REGIONAL REVIEW FINDING

ARC REVIEW CODE: R707272

Name of Proposal: Parkview Plaza MUD

Preliminary Report:	August 27, 2007	DEVELOPMENT OF REGIONAL IMPACT REVIEW REPORT	Project:	Parkview Plaza MUD #1517
Final Report Due:	September 26, 2007		Comments Due By:	September 10, 2007

V/C Ratios

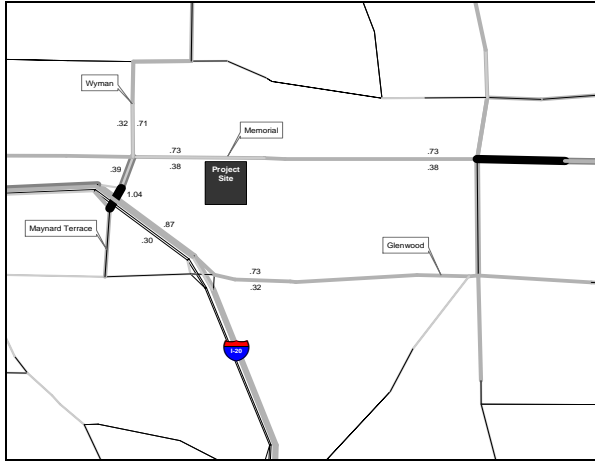
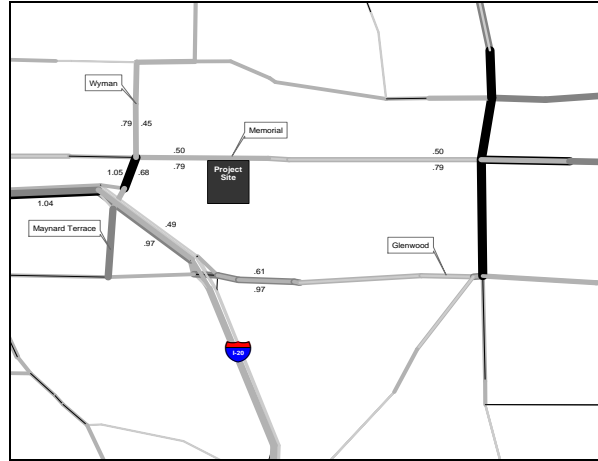
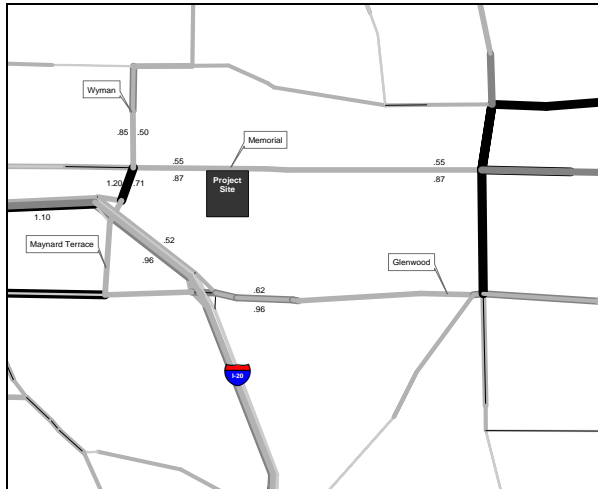
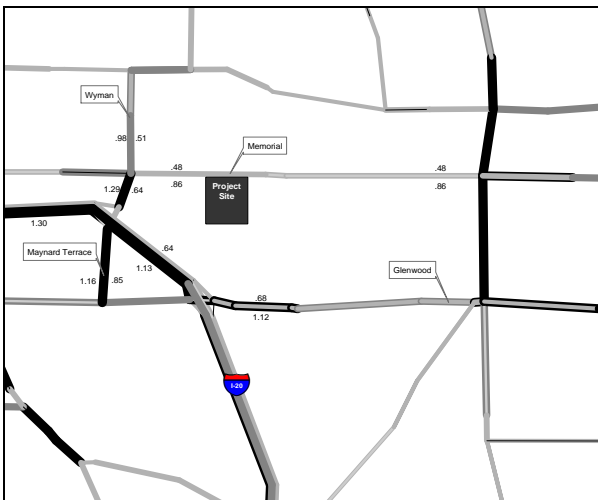
For the V/C ratio graphic, the data is based on 2005, 2010 and 2030 AM/PM peak volume data generated from ARC's 20-county travel demand model utilizing projects from Mobility 2030 and the FY 2006-2011 TIP. The 20-county networks are being used since they consist of the most up to date transportation networks and data. The travel demand model incorporates lane addition improvements and updates to the network as appropriate. As the life of the RTP progresses, volume and/or V/C ratio data may appear inconsistent due to (1) effect of implementation of nearby new or expanded facilities or (2) impact of socio-economic data on facility types.
